LIC-16-0076  
September 2, 2016

Fort Calhoun Station, Unit No. 1  
Renewed Facility Operating License No. DPR-40  
NRC Docket No. 50-285

Subject: License Amendment Request (LAR) 16-02: Revise the Fort Calhoun Station Emergency Plan to Address the Permanently Defueled Condition

Attachment 2 - Figure B-2 - Fort Calhoun Station Emergency Response Organization

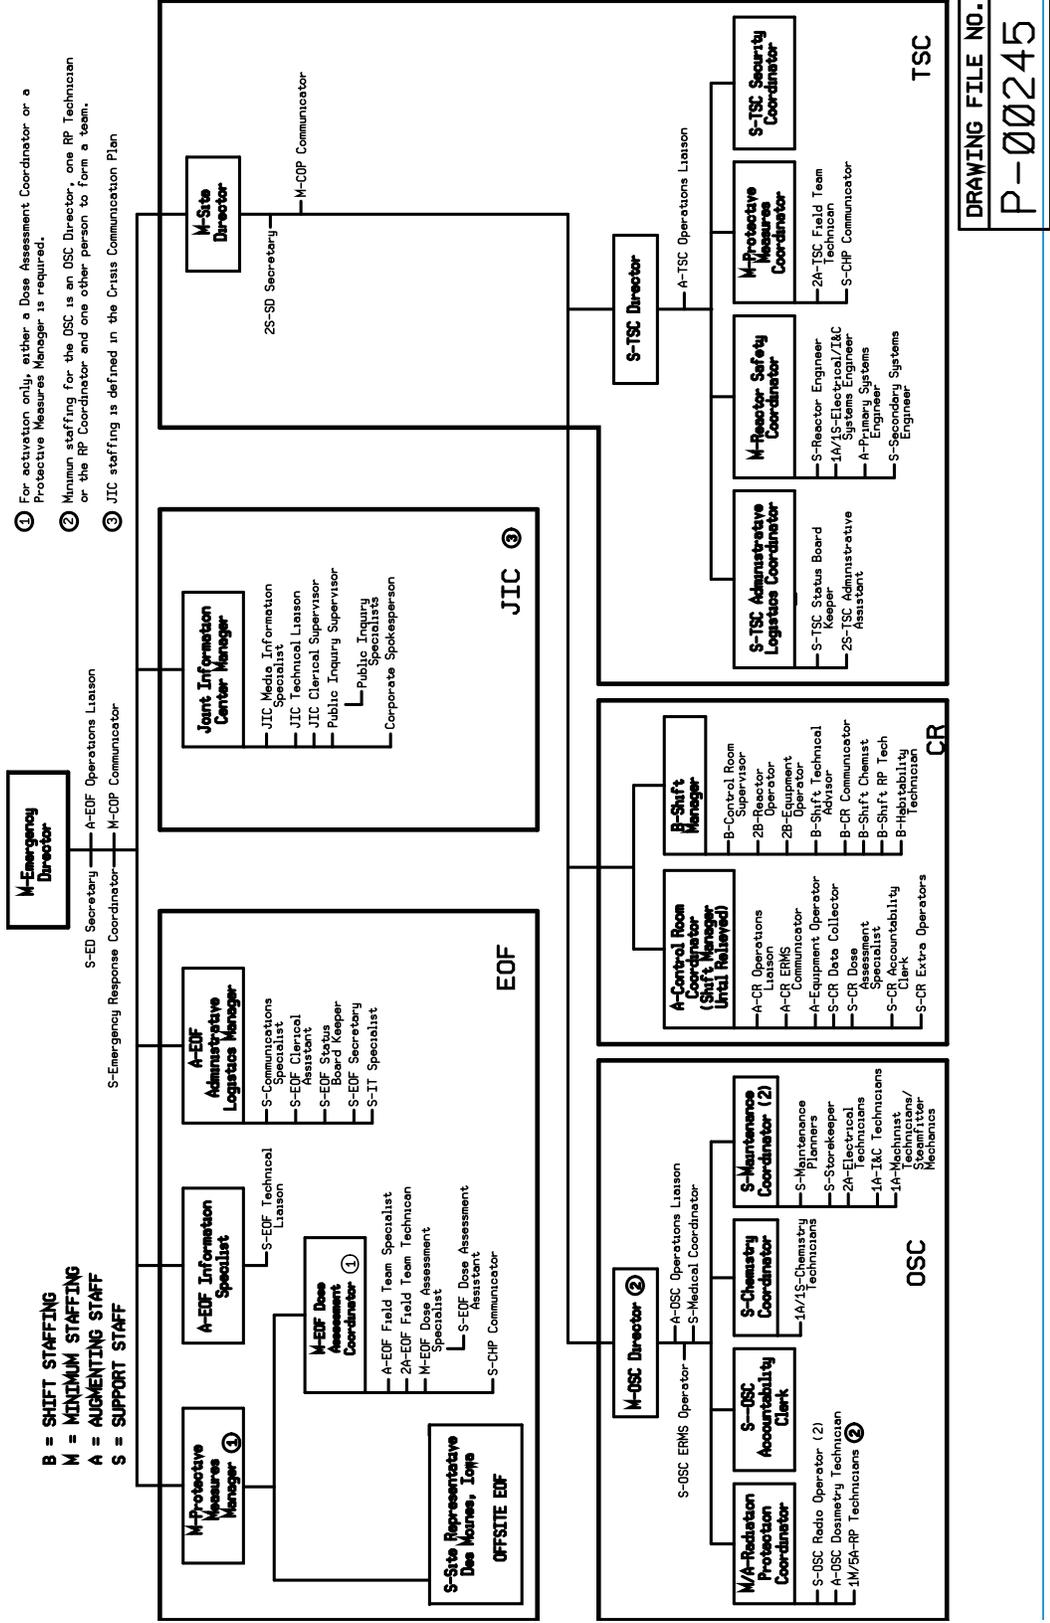
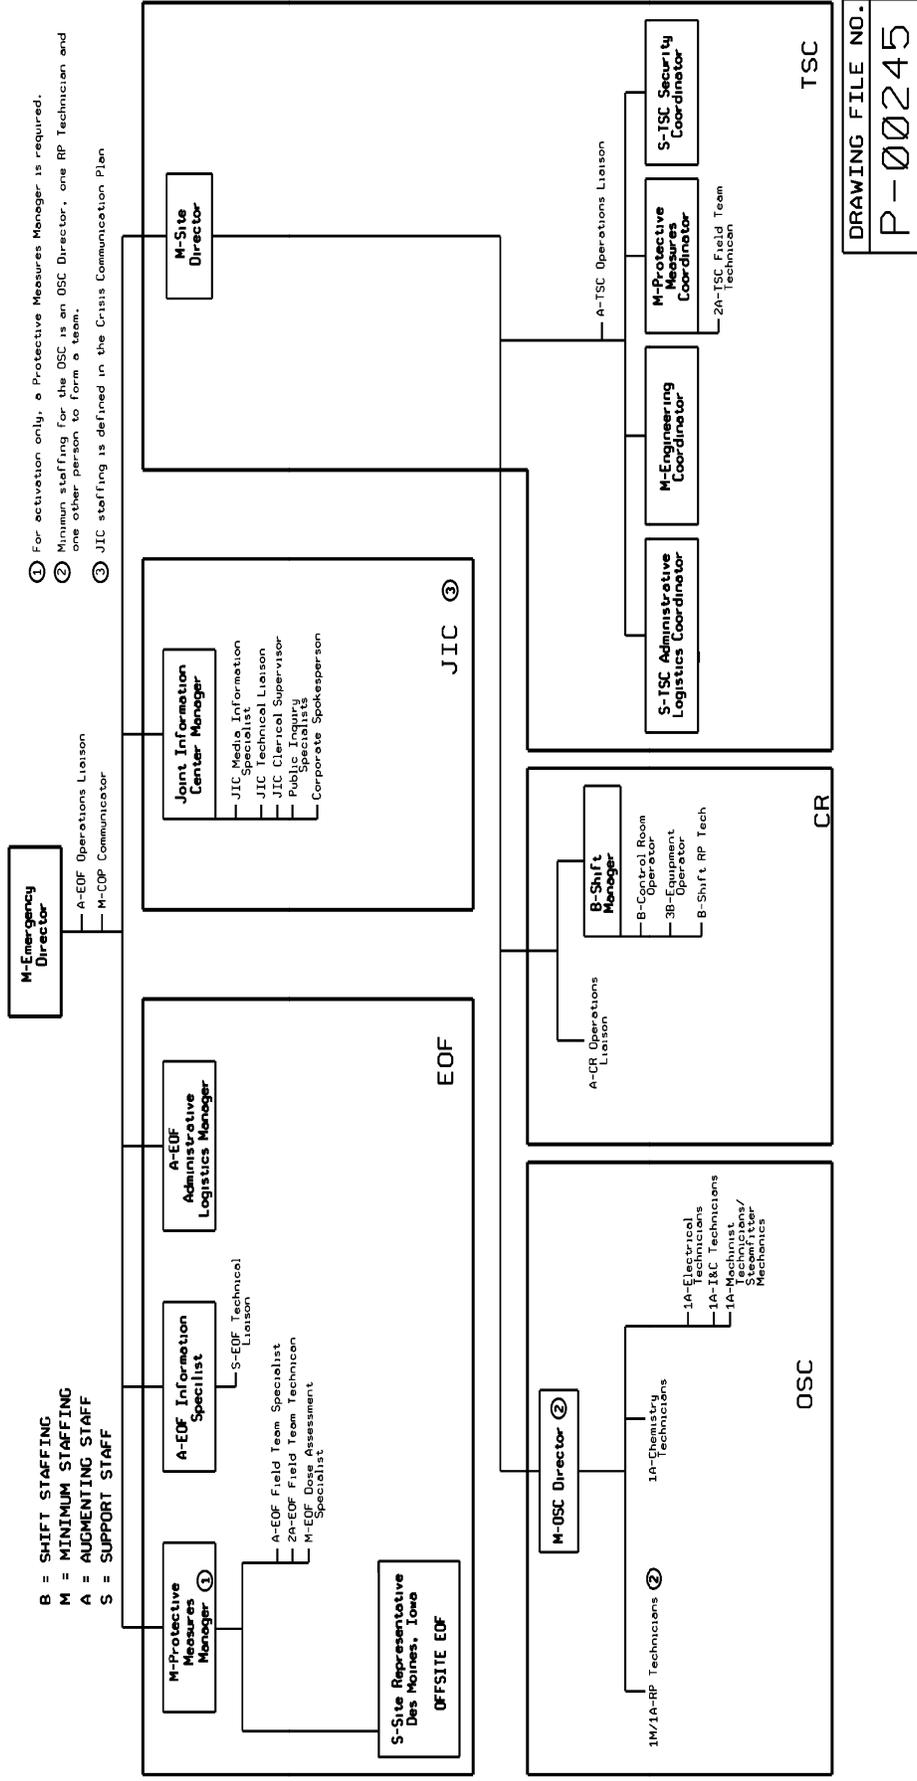
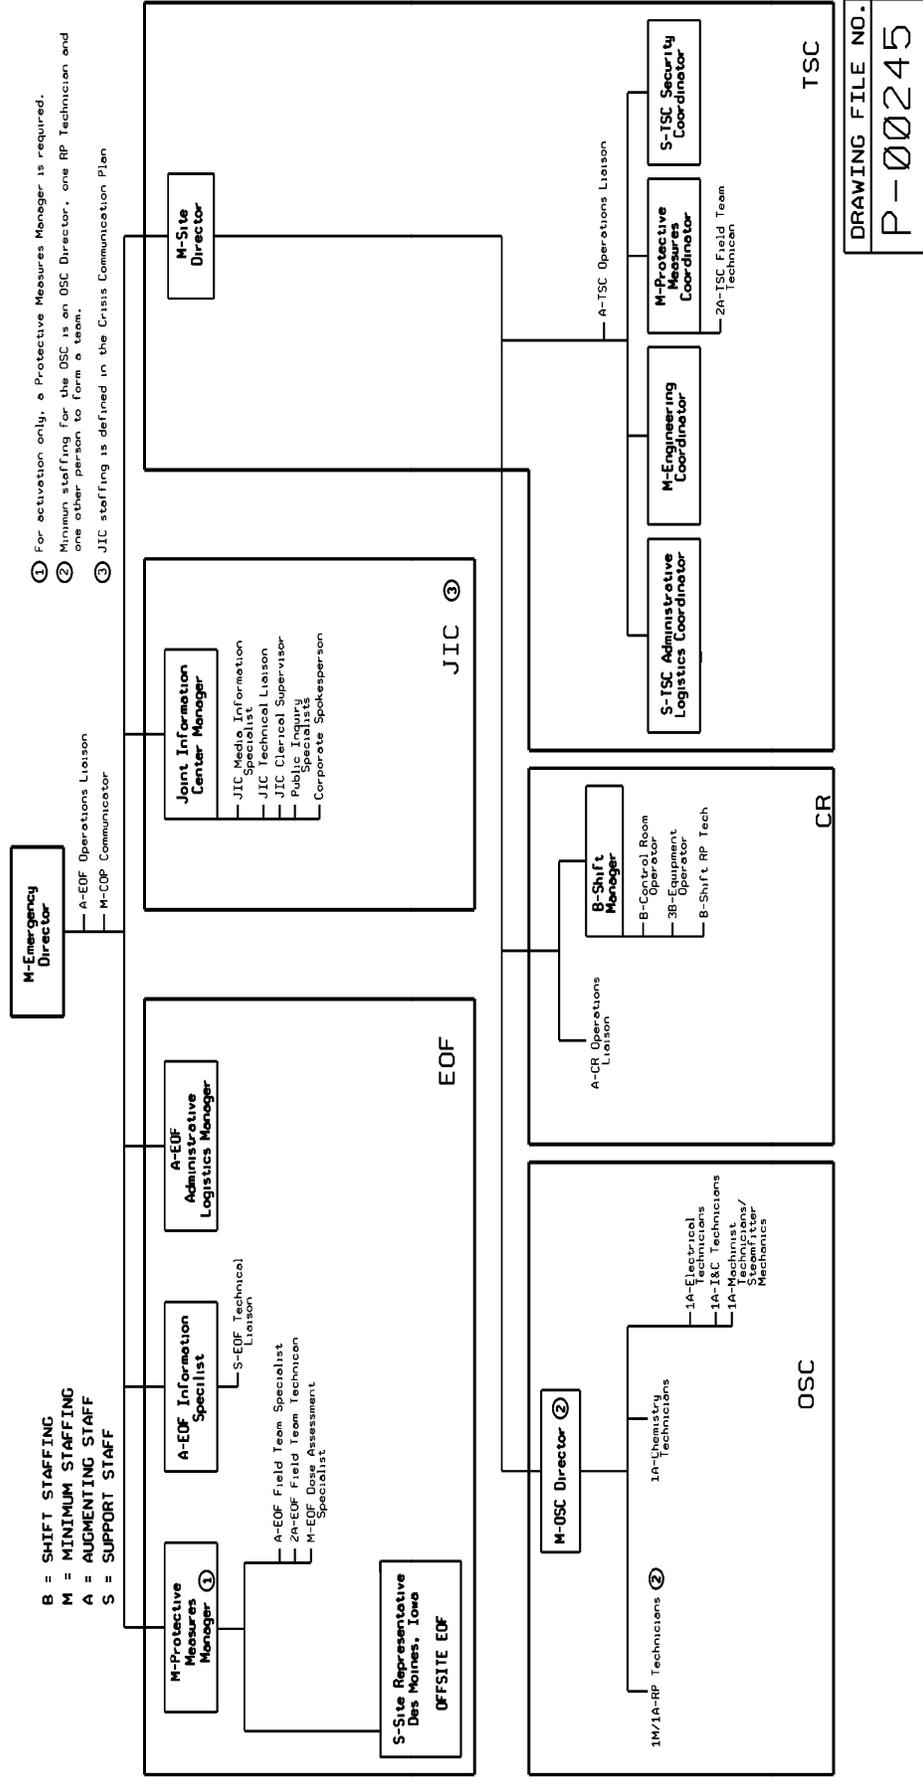
Section B, Attachment 2-Figure B-2	S – EOF Dose Assessment Assistant	Deleted	The EOF Dose Assessment Assistant position will not exist in the post-shutdown ERO. The proposed elimination of the EOF Dose Assessment Assistant position has been evaluated in the FCS analysis of proposed post-shutdown ERO staffing.

<b>Emergency Plan Section</b>	<b>Before (Rev. 1)</b>	<b>After (Pending Revision Number)</b>	<b>Reason for Change</b>
Section B, Attachment 2-Figure B-2	S – CHP Communicator	Deleted	The CHP Communicator position will not exist in the post-shutdown ERO. The EOF Protective Measures Manager and the EOF Technical Liaison will perform the functions as needed. The proposed elimination of the CHP Communicator position has been evaluated in the FCS analysis of proposed post-shutdown ERO staffing. Duties and responsibilities will be transferred to remaining ERO positions.
Section B, Attachment 2-Figure B-2	S – Communications Specialist	Deleted	The Communications Specialist position will not exist in the post-shutdown ERO. The proposed elimination of the Communications Specialist position has been evaluated in the FCS analysis of proposed post-shutdown ERO staffing.
Section B, Attachment 2-Figure B-2	S – EOF Clerical Assistant	Deleted	The EOF Clerical Assistant position will not exist in the post-shutdown ERO. The EOF Information Specialist and the Admin Logistics Manager will perform the functions as needed. The proposed elimination of the EOF Clerical Assistant position has been evaluated in the FCS analysis of proposed post-shutdown ERO staffing. Duties and responsibilities will be transferred to remaining ERO positions.

<b>Emergency Plan Section</b>	<b>Before (Rev. 1)</b>	<b>After (Pending Revision Number)</b>	<b>Reason for Change</b>
Section B, Attachment 2-Figure B-2	S – EOF Status Board Keeper	Deleted	The EOF Status Board Keeper position will not exist in the post-shutdown ERO. The proposed elimination of the EOF Status Board Keeper position has been evaluated in the FCS analysis of proposed post-shutdown ERO staffing.
Section B, Attachment 2-Figure B-2	S – EOF Secretary	Deleted	The EOF Secretary position will not exist in the post-shutdown ERO. The proposed elimination of the EOF Secretary position has been evaluated in the FCS analysis of proposed post-shutdown ERO staffing.
Section B, Attachment 2-Figure B-2	S – IT Specialist	Deleted	The IT Specialist position will not exist in the post-shutdown ERO. The proposed elimination of the IT Specialist position has been evaluated in the FCS analysis of proposed post-shutdown ERO staffing.

Emergency Plan Section	Before (Rev. 1)	After (Pending Revision Number)	Reason for Change
Section B, Attachment 2-Figure B-2	Public Inquiry Supervisor	Deleted	The Public Inquiry Supervisor position will not exist in the post-shutdown ERO. The JIC Manager and Public Inquiry Specialist will perform this function as needed. The proposed elimination of the Public Inquiry Supervisor position has been evaluated in the FCS analysis of proposed post-shutdown ERO staffing. Duties and responsibilities will be transferred to remaining ERO positions.
Section B, Attachment 2-Figure B-2	2S – SD Secretary	Deleted	The Site Director Secretary position will not exist in the post-shutdown ERO. The proposed elimination of the Site Director Secretary position has been evaluated in the FCS analysis of proposed post-shutdown ERO staffing.
Section B, Attachment 2-Figure B-2	M – COP Communicator	Deleted	The TSC COP Communicator position will not exist in the post-shutdown ERO, as previously described.

Section B, Attachment 2-Figure B-2	S – OSC ERMS Operator	Deleted	The OSC ERMS Operator position will not exist in the post-shutdown ERO. The proposed elimination of the OSC ERMS Operator position has been evaluated in the FCS analysis of proposed post-shutdown ERO staffing.
Section B, Attachment 2-Figure B-2	A – OSC Operations Liaison	Deleted	The OSC Operations Liaison position will not exist in the post-shutdown ERO, as previously described.

Emergency Plan Section	Before (Rev. 1)	After (Pending Revision Number)	Reason for Change
Section B, Attachment 2-Figure B-2	S – Medical Coordinator	Deleted	The Medical Coordinator position will not exist in the post-shutdown ERO. The OSC Director will perform the functions as needed. The proposed elimination of the OSC Medical Response Coordinator position has been evaluated in the FCS analysis of proposed post-shutdown ERO staffing. Duties and responsibilities will be transferred to remaining ERO positions.
Section B, Attachment 2-Figure B-2	M/A – Radiation Protection Coordinator	Deleted	The Radiation Protection Coordinator position will not exist in the post-shutdown ERO, as previously described.
Section B, Attachment 2-Figure B-2	S – OSC Radio Operator (2)	Deleted	The OSC Radio Operator position will not exist in the post-shutdown ERO. The proposed elimination of the OSC Radio Operator position has been evaluated in the FCS analysis of proposed post-shutdown ERO staffing.

Section B, Attachment 2-Figure B-2	A – OSC Dosimetry Technician	Deleted	The OSC Dosimetry Technician position will not exist in the post-shutdown ERO, as previously described.

<b>Emergency Plan Section</b>	<b>Before (Rev. 1)</b>	<b>After (Pending Revision Number)</b>	<b>Reason for Change</b>
Section B, Attachment 2-Figure B-2	S – OSC Accountability Clerk	Deleted	The OSC Accountability Clerk position will not exist in the post-shutdown ERO. The proposed elimination of the OSC Accountability Clerk position has been evaluated in the FCS analysis of proposed post-shutdown ERO staffing.
Section B, Attachment 2-Figure B-2	S – Chemistry Coordinator	Deleted	The Chemistry Coordinator position will not exist in the post-shutdown ERO, as previously described.
Section B, Attachment 2-Figure B-2	S – Maintenance Coordinator (2)	Deleted	The Maintenance Coordinator position will not exist in the post-shutdown ERO. The OSC Director will perform the functions as needed. The proposed elimination of the Maintenance Coordinator position has been evaluated in the FCS analysis of proposed post-shutdown ERO staffing. Duties and responsibilities will be transferred to remaining ERO positions.

Section B, Attachment 2-Figure B-2	S – OSC Maintenance Planners	Deleted	The OSC Maintenance Planner position will not exist in the post-shutdown ERO. The proposed elimination of the OSC Maintenance Planner position has been evaluated in the FCS analysis of proposed post-shutdown ERO staffing.

Emergency Plan Section	Before (Rev. 1)	After (Pending Revision Number)	Reason for Change
Section B, Attachment 2-Figure B-2	S - Storekeeper	Deleted	The Storekeeper position will not exist in the post-shutdown ERO. The proposed elimination of the Store Keeper position has been evaluated in the FCS analysis of proposed post-shutdown ERO staffing.
Section B, Attachment 2-Figure B-2	A – Control Room Coordinator (Shift Manager Until Relieved)	Deleted	The Control Room Coordinator position will not exist in the post-shutdown ERO, as previously described.
Section B, Attachment 2-Figure B-2	A –CR ERMS Communicator	Deleted	The CR ERMS Communicator position will not exist in the post-shutdown ERO, as previously described.
Section B, Attachment 2-Figure B-2	A – Equipment Operator	Deleted	The augmenting Equipment Operator position will not exist in the post-shutdown ERO, as previously described.
Section B, Attachment 2-Figure B-2	S – CR Data Collector	Deleted	The CR Data Collector position will not exist in the post-shutdown ERO, as previously described.

Section B, Attachment 2-Figure B-2	S – CR Dose Assessment Specialist	Deleted	The Control Room Dose Assessment Specialist position will not exist in the post-shutdown ERO, as previously described.
Section B, Attachment 2-Figure B-2	S – CR Accountability Clerk	Deleted	The CR Accountability position will not exist in the post-shutdown ERO, as previously described.

<b>Emergency Plan Section</b>	<b>Before (Rev. 1)</b>	<b>After (Pending Revision Number)</b>	<b>Reason for Change</b>
Section B, Attachment 2-Figure B-2	S – CR Extra Operators	Deleted	The CR Extra Operator position will not exist in the post-shutdown ERO, as previously described.
Section B, Attachment 2-Figure B-2	B - Control Room Supervisor	B - Control Room Operator	Title change as previously described.
Section B, Attachment 2-Figure B-2	2B – Reactor Operator	Deleted	The Reactor Operator position will not exist in the post-shutdown ERO, as previously described.
Section B, Attachment 2-Figure B-2	B – Shift Technical Advisor	Deleted	The Shift Technical Advisor position will not exist in the post-shutdown ERO, as previously described.
Section B, Attachment 2-Figure B-2	B – CR Communicator	Deleted	The Control Room Communicator position will not exist in the post-shutdown ERO, as previously described.

Section B, Attachment 2-Figure B-2	S – Shift Chemist	Deleted	The Shift Chemist position will not exist in the post-shutdown ERO, as previously described.
Section B, Attachment 2-Figure B-2	S – Habitability Technician	Deleted	The Habitability Technician position will not exist in the post-shutdown ERO, as previously described.
Section B, Attachment 2-Figure B-2	S – TSC Status Board Keeper	Deleted	The TSC Status Board Keeper position will not exist in the post-shutdown ERO.
Section B, Attachment 2-Figure B-2	2S – TSC Administrative Assistant	Deleted	The TSC Administrative Assistant position will not exist in the post-shutdown ERO.
Section B, Attachment 2-Figure B-2	M – Reactor Safety Coordinator	M-Engineering Coordinator	Title change as previously described.

<b>Emergency Plan Section</b>	<b>Before (Rev. 1)</b>	<b>After (Pending Revision Number)</b>	<b>Reason for Change</b>
Section B, Attachment 2-Figure B-2	S – Reactor Engineer	Deleted	The Reactor Engineer position will not exist in the post-shutdown ERO. The TSC Reactor Safety coordinator (retitled to Engineering Coordinator) will perform the functions as needed. The proposed elimination of the Reactor Engineer position has been evaluated in the FCS analysis of proposed post-shutdown ERO staffing. Duties and responsibilities will be transferred to remaining ERO positions.
Section B, Attachment 2-Figure B-2	1A/1S – Electrical/I&C Systems Engineer	Deleted	The Electrical/I&C Systems Engineer position will not exist in the post-shutdown ERO, as previously described.
Section B, Attachment 2-Figure B-2	A – Primary Systems Engineer	Deleted	The Primary Systems Engineer position will not exist in the post-shutdown ERO, as previously described.

Emergency Plan Section	Before (Rev. 1)	After (Pending Revision Number)	Reason for Change
Section B, Attachment 2-Figure B-2	S – Secondary Systems Engineer	Deleted	The Secondary Systems Engineer position will not exist in the post-shutdown ERO. The TSC Reactor Safety coordinator (retitled to Engineering Coordinator) will perform the functions as needed. The proposed elimination of the Secondary Systems Engineer position has been evaluated in the FCS analysis of proposed post-shutdown ERO staffing. Duties and responsibilities will be transferred to remaining ERO positions.
Section B, Attachment 2-Figure B-2	S – CHP Communicator	Deleted	The CHP Communicator position will not exist in the post-shutdown ERO. The TSC Protective Measures Coordinator and the TSC Ops Liaison will perform the functions as needed. The proposed elimination of the CHP Communicator position has been evaluated in the FCS analysis of proposed post-shutdown ERO staffing. Duties and responsibilities will be transferred to remaining ERO positions.

Section B, Attachment 2-Figure B-2, NOTE 1	For activation only, either a Dose Assessment Coordinator or a Protective Measures Manager is required.	For activation only, a Protective Measures Manager is required.	The Dose Assessment Coordinator position will not exist in the post-shutdown ERO as previously described.

<b>Emergency Plan Section</b>	<b>Before (Rev. 1)</b>	<b>After (Pending Revision Number)</b>	<b>Reason for Change</b>
Section B, Attachment 2-Figure B-2, NOTE 2	Minimum staffing for the OSC is an OSC Director, one RP Technician or the RP Coordinator and one other person to form a team.	Minimum staffing for the OSC is an OSC Director, one RP Technician and one other person to form a team.	The RP Coordinator position will not exist in the post-shutdown ERO as previously described.
Section D, 1.1	The Emergency Classification scheme is based on NEI-99-01, Revision 5, Methodology for Development of Emergency Action Levels.	The Emergency Classification scheme is based on NEI-99-01, Revision 6, Development of Emergency Action Levels for Non-Passive Reactors.	Editorial change to reflect previous EAL update.
Section D, 2.4 3 <sup>rd</sup> Sentence	Immediate actions to be taken in response to conditions involving abnormal plant operating parameters are detailed in the Fort Calhoun Station Emergency Operating Procedures, Abnormal Operating Procedures and Operating Instructions. Other immediate actions and follow-up actions are identified in Section J of this plan and are described in detail in applicable Emergency Plan Implementing Procedures, listed in Appendix C of this plan.	Immediate actions to be taken in response to conditions involving abnormal plant operating parameters are detailed in the Fort Calhoun Station Abnormal Operating Procedures and Operating Instructions. Other immediate actions and follow-up actions are identified in Section J of this plan and are described in detail in applicable Emergency Plan Implementing Procedures, listed in Appendix C of this plan.	FCS will no longer be an operating nuclear power plant.
